**Re:    *Virginia Electric and Power Company,*  
      **Docket No. ER18-2355-000**  
      **Amendment to Transmission Interconnection Agreement****

Pursuant to Section 205 of the Federal Power Act (“FPA”)<sup>1</sup> and Part 35 of the Rules and Regulations of the Federal Energy Regulatory Commission<sup>2</sup> (“FERC” or “Commission”), Virginia Electric and Power Company, doing business as Dominion Energy Virginia in the Commonwealth of Virginia and Dominion Energy North Carolina in the State of North Carolina (collectively “Dominion”), on its behalf and on behalf of Duke Energy Progress, LLC (“DEP”), hereby tenders for filing amendments to a transmission interconnection agreement (“Interconnection Agreement” or “IA”) between Dominion and DEP. The amendment reflects a change in the point of interconnection for the existing “Battleboro – Rocky Mount 115 kV Interconnection Point”.

**Figure 2**  
**Battleboro – Rocky Mount 115 kV Interconnection Point**

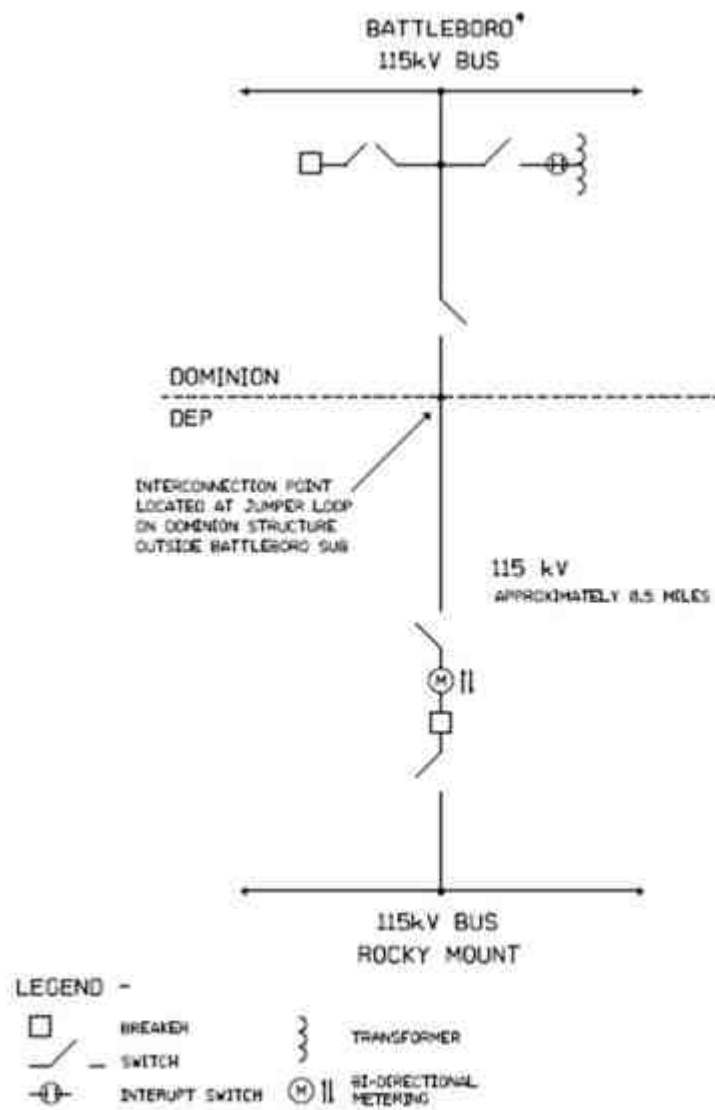
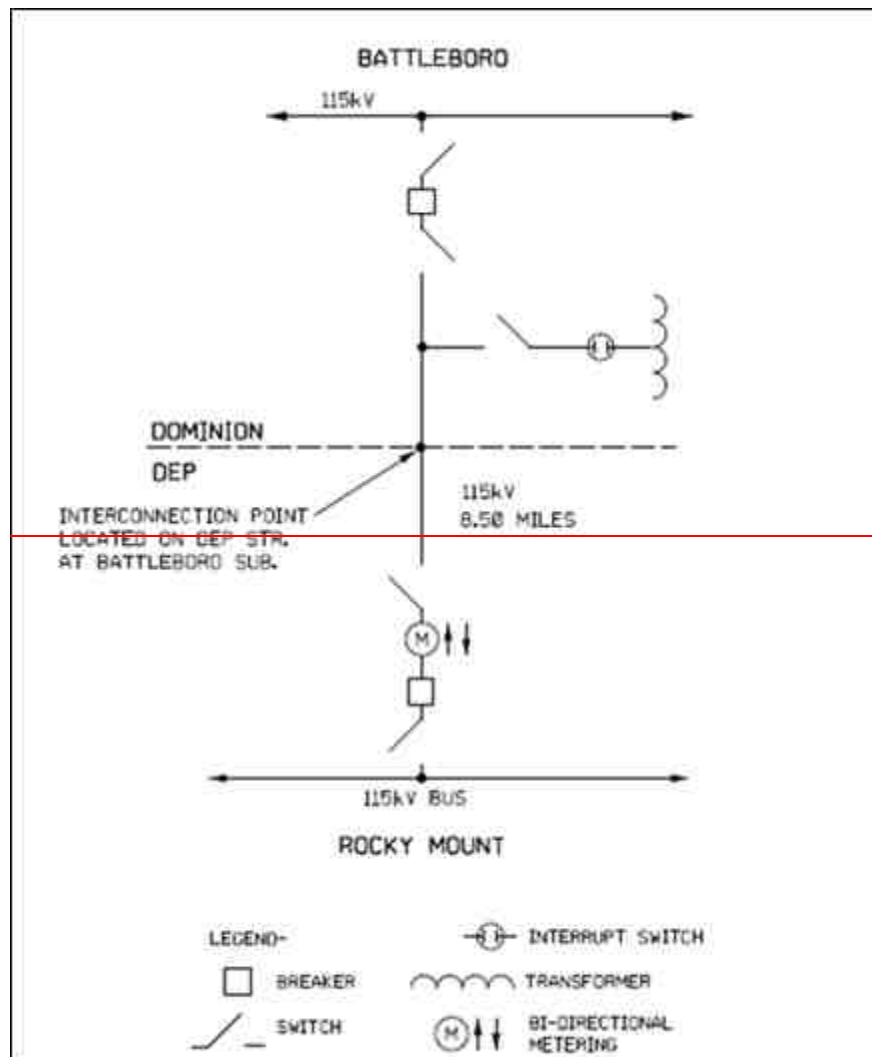
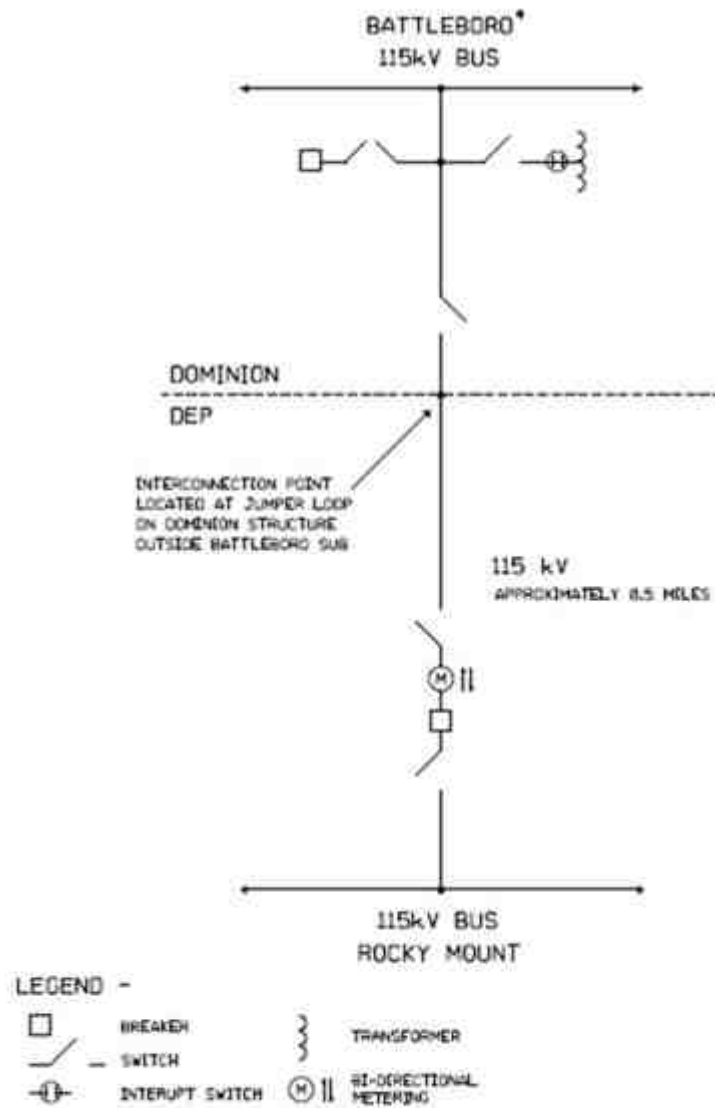
Section 1.1.2 of Appendix I to the Interconnection Agreement describes the “Battleboro – Rocky Mount 115 kV Interconnection Point,” and Figure 2 to Appendix I is a one-line of that interconnection point.

Dominion identified the need to replace a circuit switcher within Dominion-owned Battleboro Substation and install a line switch in order to isolate the transformer within Battleboro Substation from the “Battleboro – Rocky Mount 115 kV Interconnection Point”.

The point hereby designated and hereinafter called “**Battleboro – Rocky Mount 115 kV** Interconnection Point.” The point of interconnection is within the 115 kV single circuit transmission line extending from the 115 kV bus in DEP’s Rocky Mount Station to the 115 kV bus in Dominion Energy’s Battleboro Station. The change of ownership occurs on a Dominion ~~DEP~~ structure located directly outside ~~inside~~ Dominion’s Battleboro Station. Bi-directional 115 kV metering equipment is installed at the Rocky Mount Station, and is owned, operated, and maintained by DEP. (See Figure 2)

- 1.1.2 The point hereby designated and hereinafter called “**Battleboro – Rocky Mount 115 kV** Interconnection Point.” The point of interconnection is within the 115 kV single circuit transmission line extending from the 115 kV bus in DEP’s Rocky Mount Station to the 115 kV bus in Dominion ~~Energy~~’s Battleboro Station. The change of ownership occurs on a ~~Dominion Energy~~ ~~DEP~~ structure located ~~directly outside~~ ~~inside~~ Dominion Energy’s Battleboro Station. Bi-directional 115 kV metering equipment is installed at the Rocky Mount Station, and is owned, operated, and maintained by DEP. (See Figure 2)

\*SECONDARY GRADE METERING EXISTS AT BATTLEBORO WITH TELEMETRY TO PJM THAT SATISFIES THE REQUIREMENTS FOR SECONDARY TIE LINE METERING PURSUANT TO PJM'S MANUAL 02, REVISION 00.

\*SECONDARY GRADE METERING EXISTS AT BATTLEBORO WITH TELEMETRY TO PJM THAT SATISFIES THE REQUIREMENTS FOR SECONDARY TIE LINE METERING PURSUANT TO PJM'S MANUAL 2L REVISION 38.
